Change Subclause 100.2.9 to the following. Remove all previous subclause headers under 100.2.9:

100.2.9 CNU transmitter requirements

Figure 7-1 - Time references for OFDMA symbol and Superframe

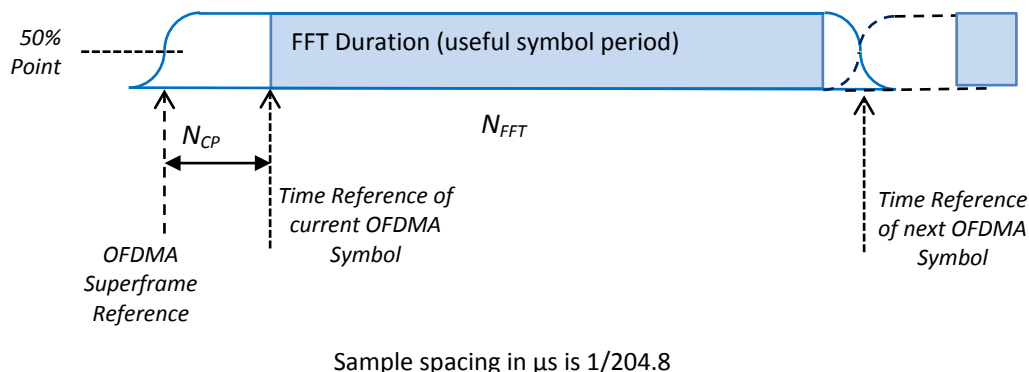
EDITOR: move figure and combine with figure in 102, then reference from here.
